From: **Troy McBride** <mcbride@norwichtech.com>
Date: Mon, Aug 23, 2021, 5:50 PM
Subject: Norwich Upper Loveland
To: Rod Francis <RFrancis@norwich.vt.us>
Cc: Martha Staskus <staskus@norwicksolar.com>, Ryan Darlow <darlow@norwicksolar.com>

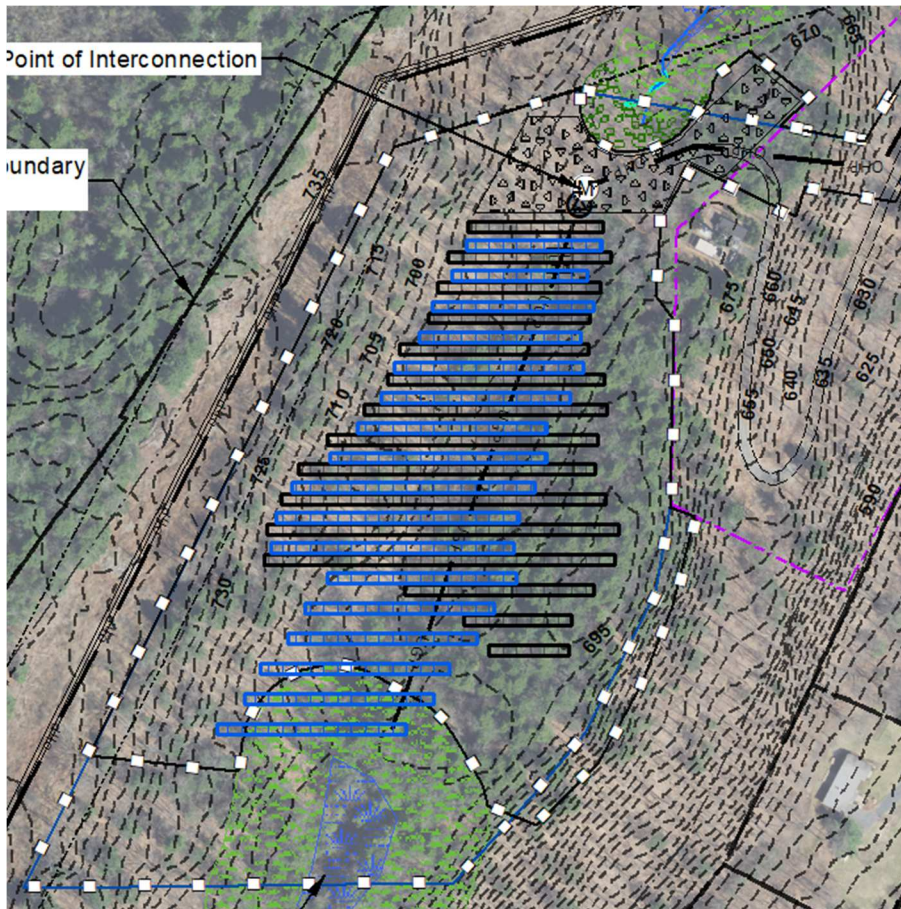
We have the environmental review on Norwich Upper Loveland and are attaching it here for your and the Planning Commission's reference. As we discussed, there is one area that is wet and was determined to be a likely vernal pool. We will observe a 100 foot buffer from that area. There is also a small stream in the north portion of the parcel, we will observe a 50 foot buffer from that area.

The two features don't change our proposed solar project much -- there is a small amount of squishing -- one feature is to the north and one to the south.

Above is the environmental map from Arrowwood Environmental and below is a sketch showing the proposed "squishing" of the solar array (black) vs presented at the Planning Commission (blue).
